BEREWOOD : PHASE 2

Design and Access Statement - Addendum

REDR130524 : April 2014

Now superseded by following layout dated April 2014

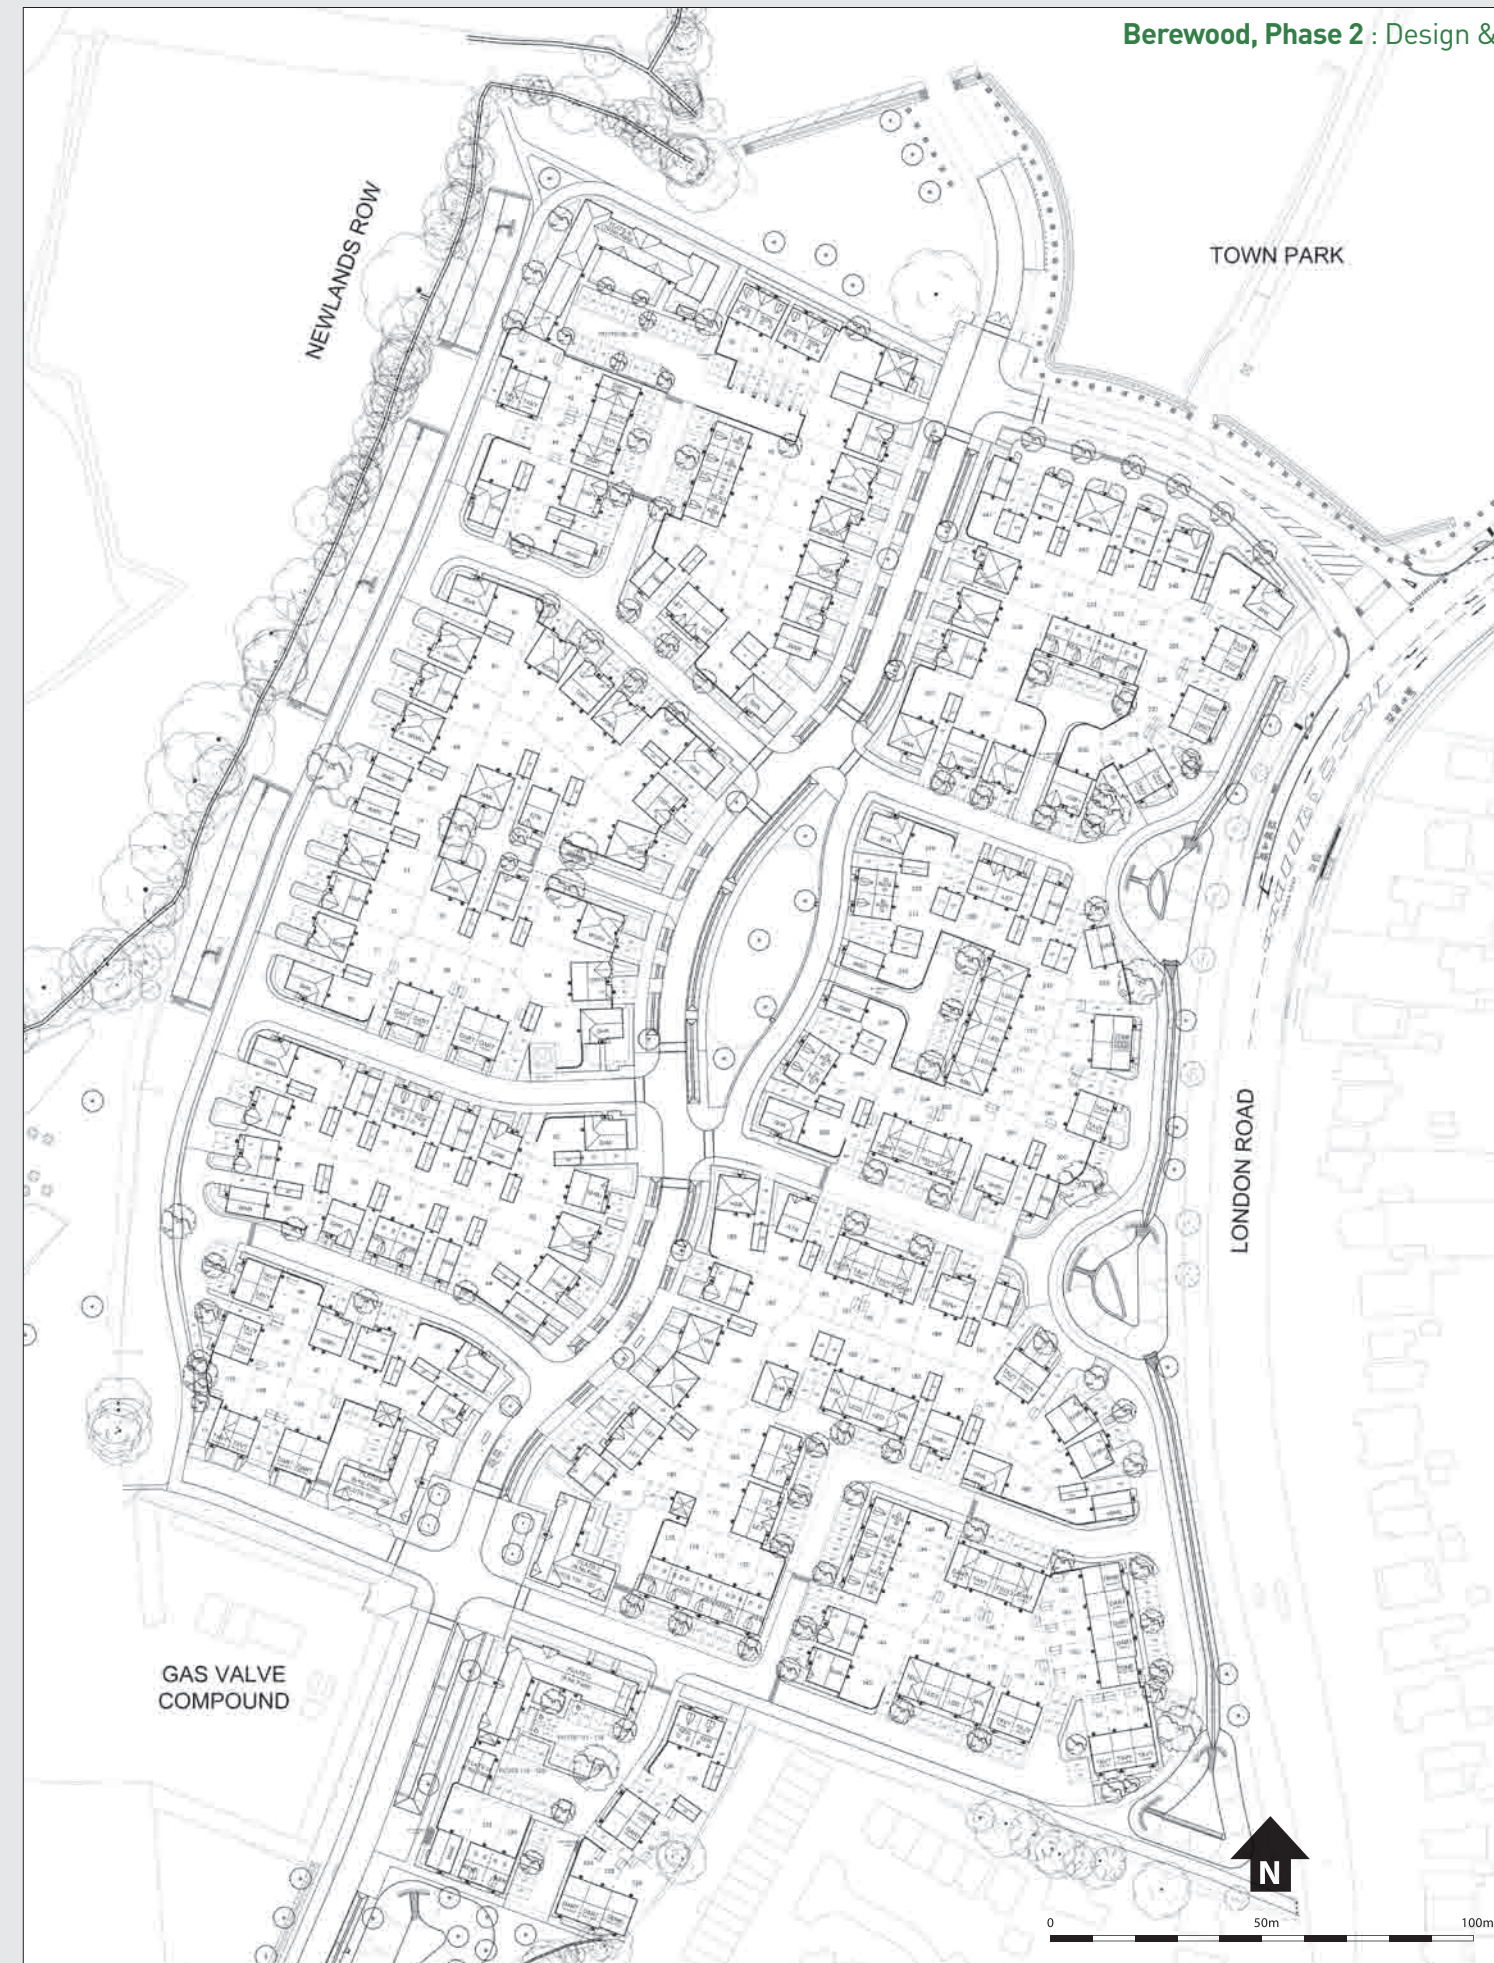
Revised Proposals

The proposed scheme has been revised to address the various consultation responses and as a result the scheme has been amended as follows:

Wheelchair Housing

The wheelchair flats have been redesigned to reduce their occupancy from two bedrooms to one bedroom to meet the required needs.

Garden Sizes & Amenity Areas

Garden sizes have been increased in length for plots 133 and 224-227. For the flats an improved garden area has been achieved to Flats C and E by reconfiguration of the parking courts and pathways. In addition balconies have been added to flat blocks; B, C & E, providing a private external area for 10 flats.

Flats A

The elevations to flat block A have been re-examined to rationalise the architectural detailing, including , a more robust eaves detail, rationalise tile hanging details, brick corbelling and dental detailing. (A more detailed description for Flat block A amendments follows towards the end of this document).

Primary Street Swale

The vehicle cross overs to the swales either side of the primary road have been reduced in width to increase the amount of unbroken swale. The reduced width cross overs have been tested for vehicle tracking into the garages.

Materials

External elevation materials have been rationalised so materials such as render, tile hanging and plinths continue around the entire building and not just the facades.

Revised Site Layout April 2014

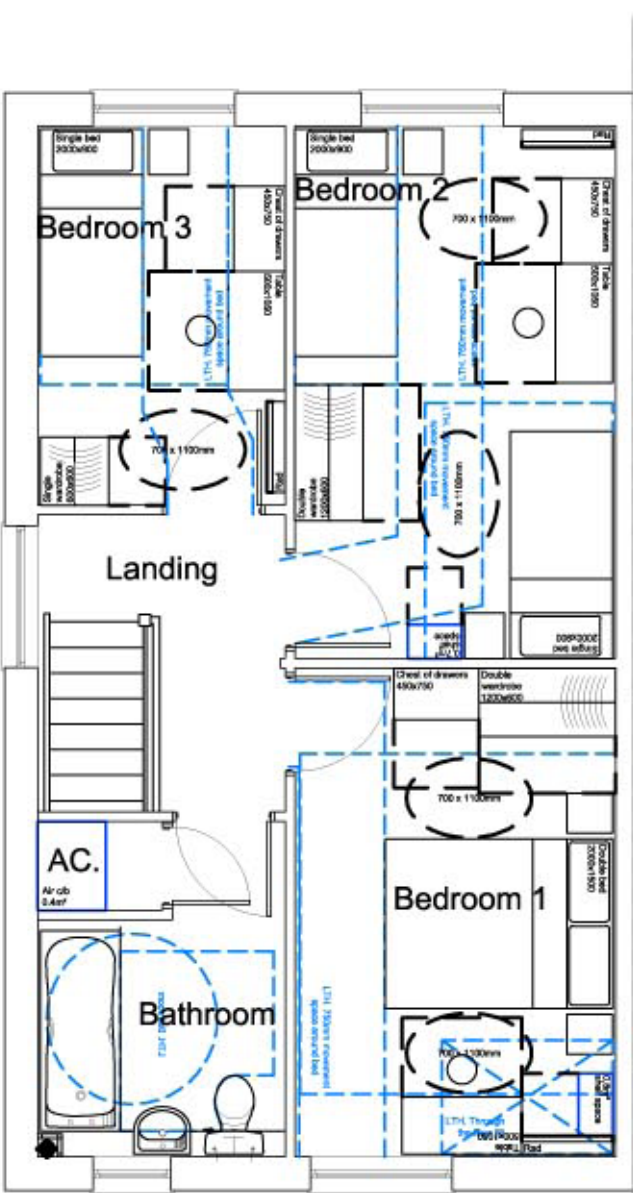
The bin collection points have been keyed with material surface treatments on the hard surfaces layout.

The parking in front of plots 93-96 has been reconfigured to provide parking better related to the properties, allow for additional landscaped areas and reduce the amount of hard surfaced.

The turning head between plots 133 & 134 has been redesigned to reduce the amount of hard surface and allow for additional landscaped area to soften this space.

Boundary details for screen walls/ fences and railings have been submitted at 1:20 scale as part of the revised submission. In particular the wall defining the courtyard to Flats A has been reduced in height to a low level (as requested) to low visual permeability to be maintained between the affordable and private housing areas.

- A larger garage has been indicated to Plot 1 which can be used as a temporary sales office.
- Drawings for the proposed substation and the garden sheds are included with the revised submission.
- Plot 187 and 240 handed to improve swale.
- Plot 235 repositioned to create improved width to adjacent drive access.

Flat block 'A' front elevation as originally submitted

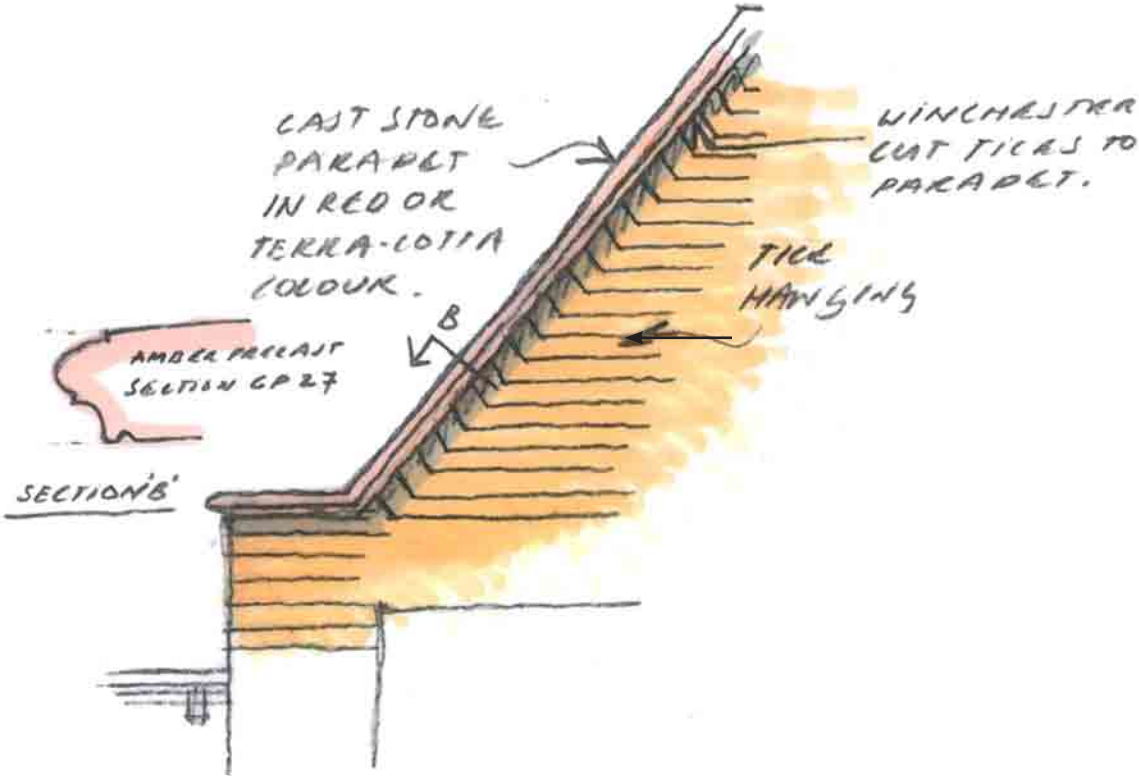
Comments on the elevational appearance of Flat Block A related to the lack of attention to detail in the CAD drawings when contrasted with the hand-drawn version. Rather than add extraneous features our approach has been to examine the elevation and enhance the architectural detail of main elements which are;

- the pair of rendered towers at each end of the elevation
- the central tile hung gable.

Sketches and coloured diagrams show where the original elevation has been amended and the details that are to be enhanced.

Tracking

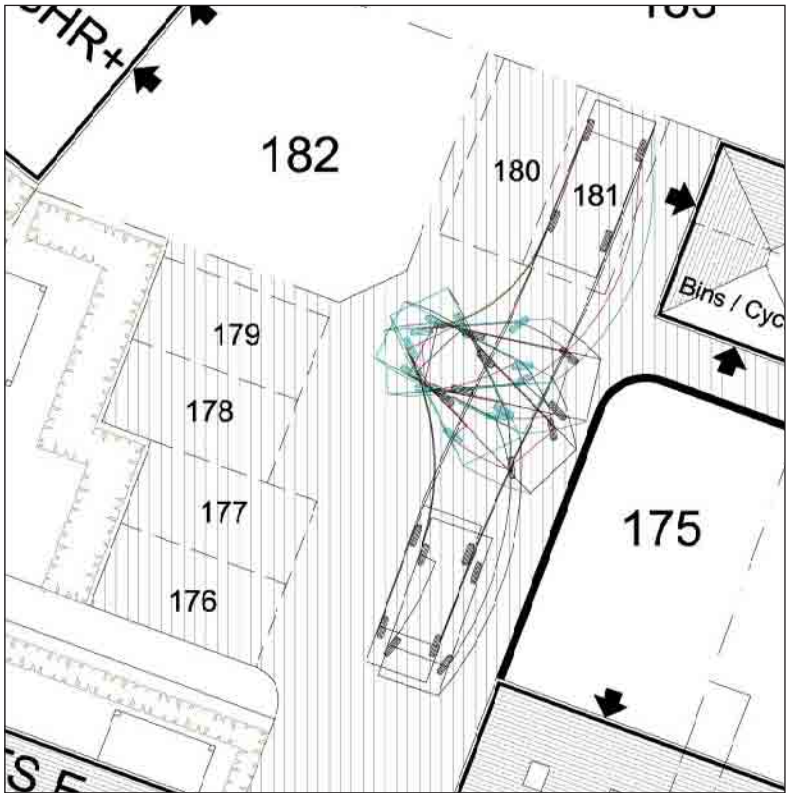
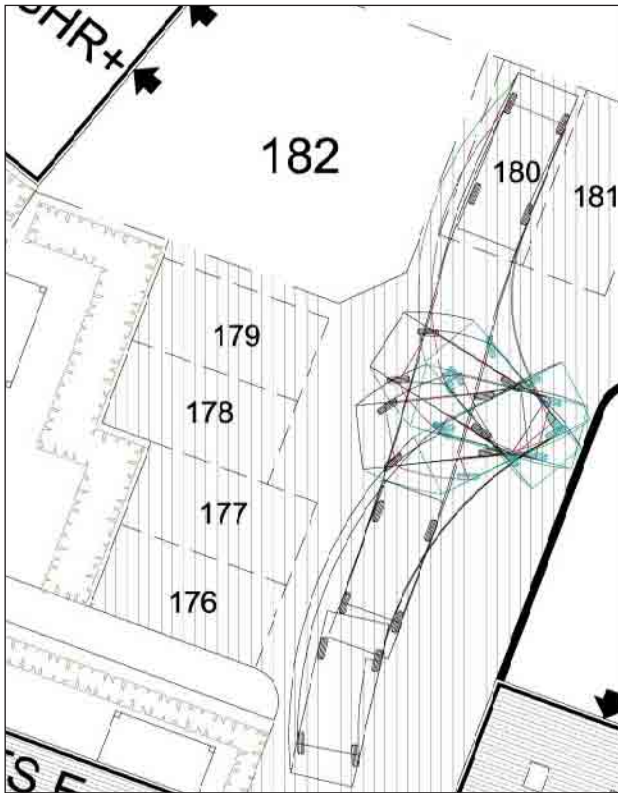
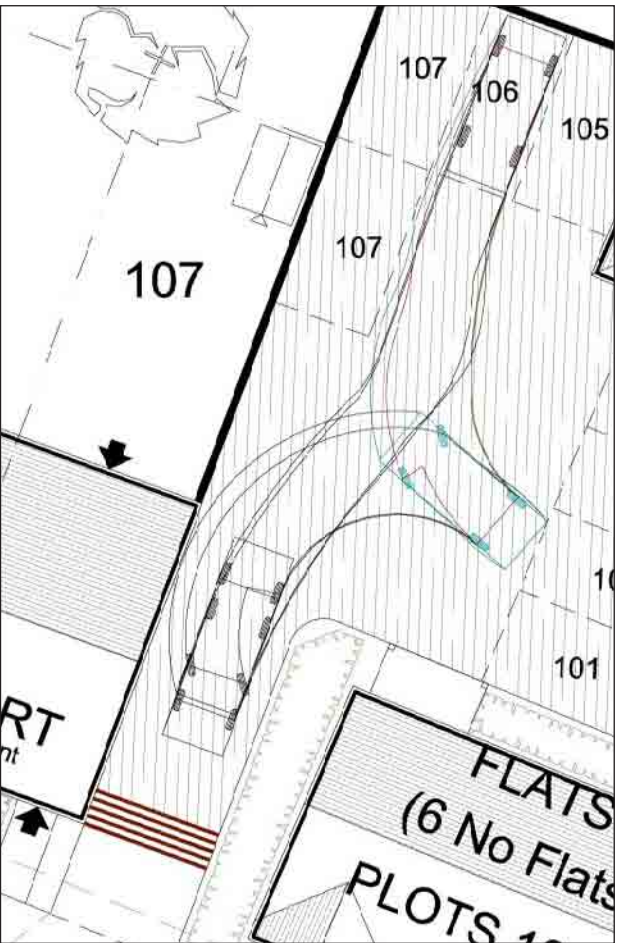
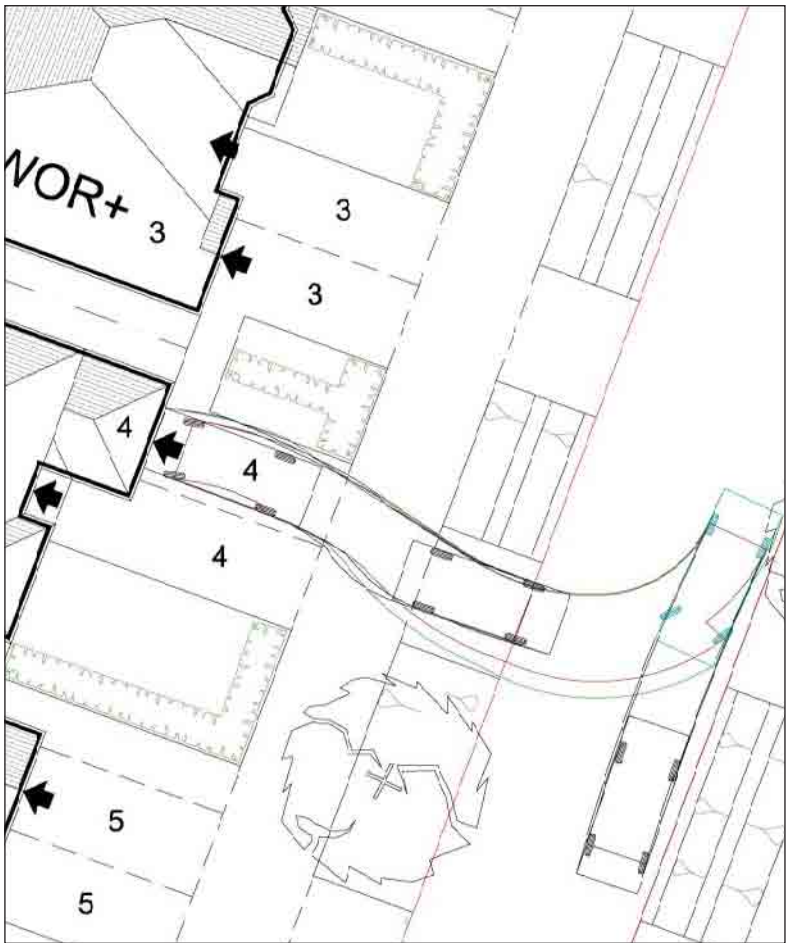
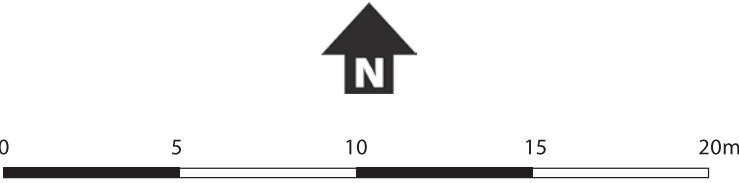
Several of the tighter parking courtyards and the revised design for the cross over to the swale have been tested for vehicle tracking. An extract of the track plots is shown on the accompanying plans.

Vehicle tracking to courtyard Flats E

Vehicle tracking to Flats B

Typical vehicle cross over to swale
